# Loss from TP0 to TP2

P802.3ck Draft 3.1 comments 41, 43

Piers Dawe, Nvidia

April 2022

# TP0-TP2 with range of max-loss host channels and current mated test fixtures

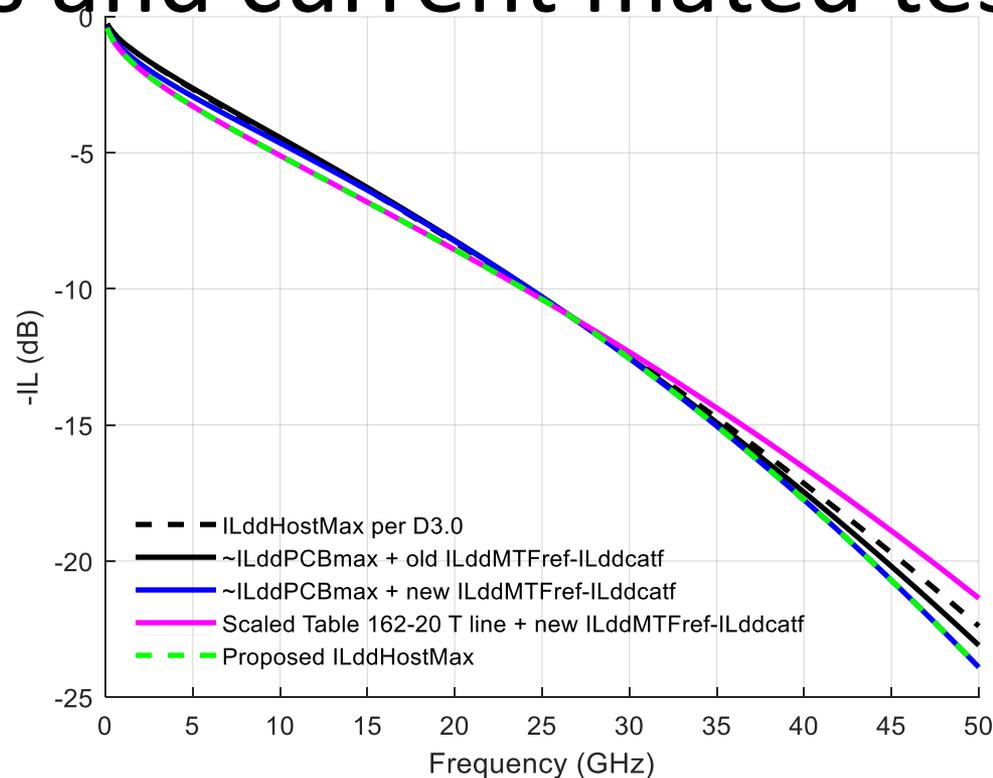
- Need to allow more curvature at low frequencies, but also roll-off well above Nyquist
- Recommend the magenta line below Nyquist and the blue above
  - A channel that rolls off more strongly than blue above ~35 GHz would work too
- Combination is shown as dashed green

- Figure 162A–2 Insertion loss from TP0 to TP2 or from TP3 to TP5

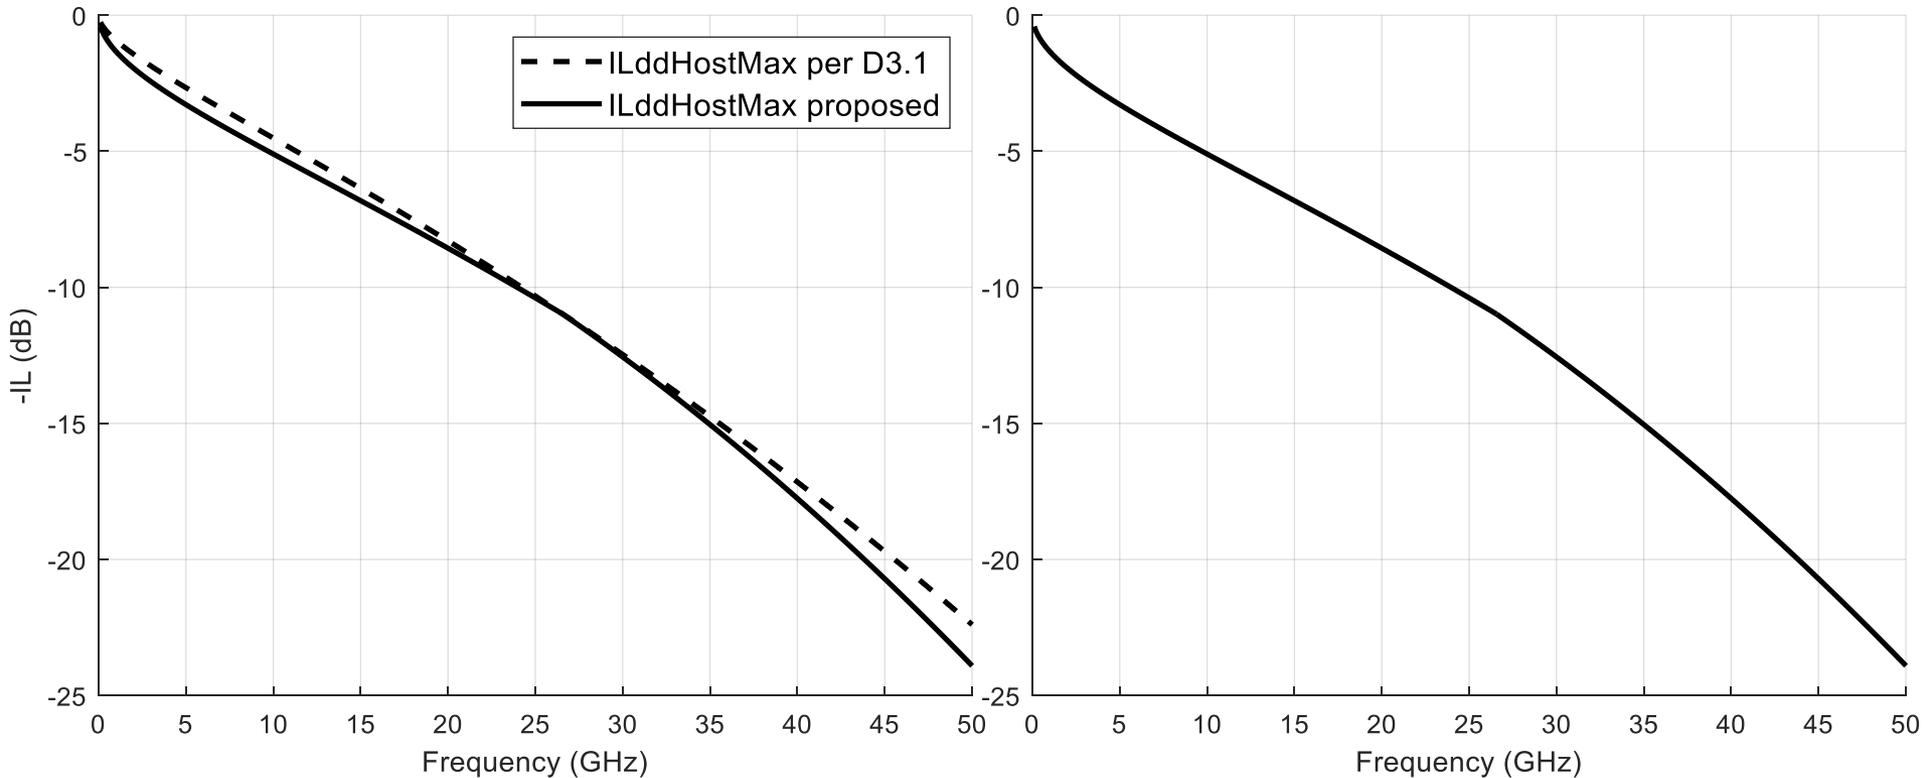
# Summary, new plot for Fig 162A–2

# Associated changes

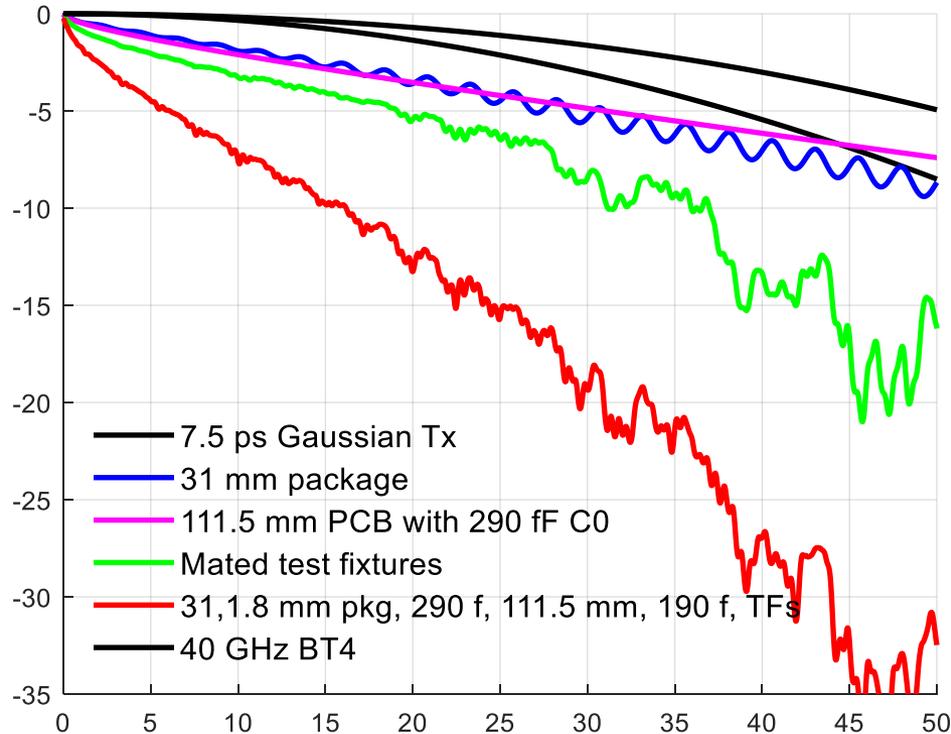
- Equation 162A–3
  - Existing:  $ILdd_{Host} \leq ILdd_{HostMax} =$   
 $1.5658*(0.471*\sqrt{f}) + 0.1194f + 0.002f^2$
  - Proposed:  $ILdd_{Host} \leq ILdd_{HostMax} =$   
 $1.2513*\sqrt{f} + 0.08007f + 0.003405f^2 \quad 0.01 \leq f \leq 26.56$   
 $1.1351*\sqrt{f} + 0.05202f + 0.005310f^2 \quad 26.56 < f \leq 50$
- Recalculate *Rpeak* (min) based on the magenta line
  - Table 162-10
  - ISI affects *Rpeak* too, so can't use the smooth curves: have to go back to more realistic models with ISI
  - Existing: 0.397
  - Proposed: 0.36

# Fitted pulse analysis

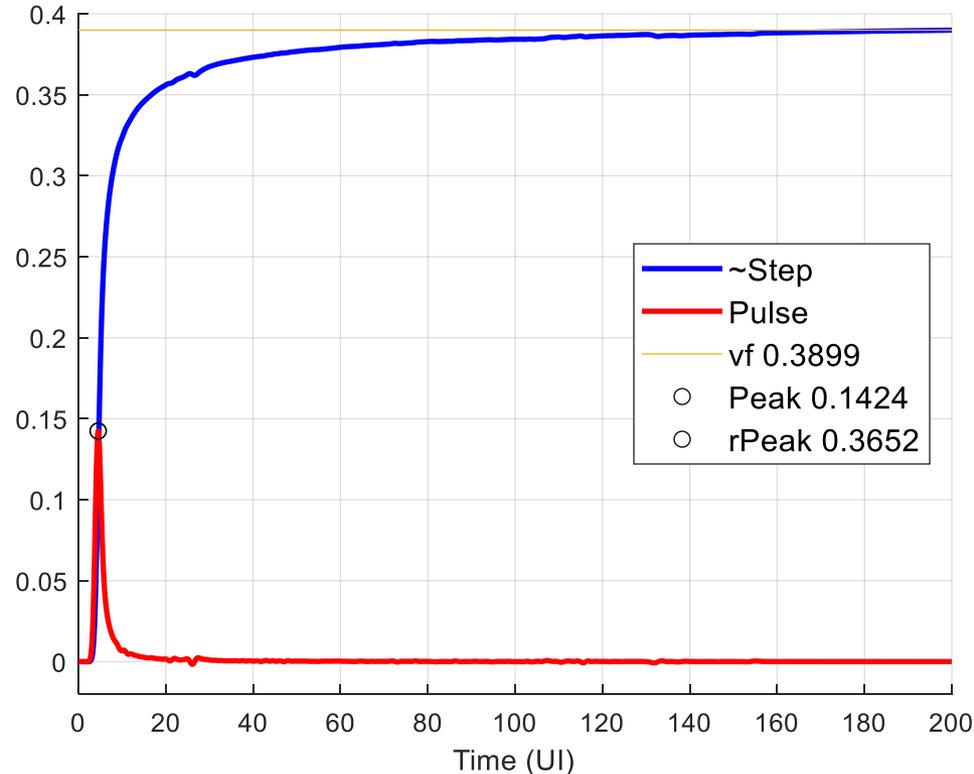
- $vf$  is just above the spec limit of 0.387 V
- $R_{peak}$  at 0.365 is different to spec limit of 0.397
- ERL is 10.5? dB; draft spec limit is 7.3. Worse ERL in real product allows worse ISI which reduces  $rPeak$
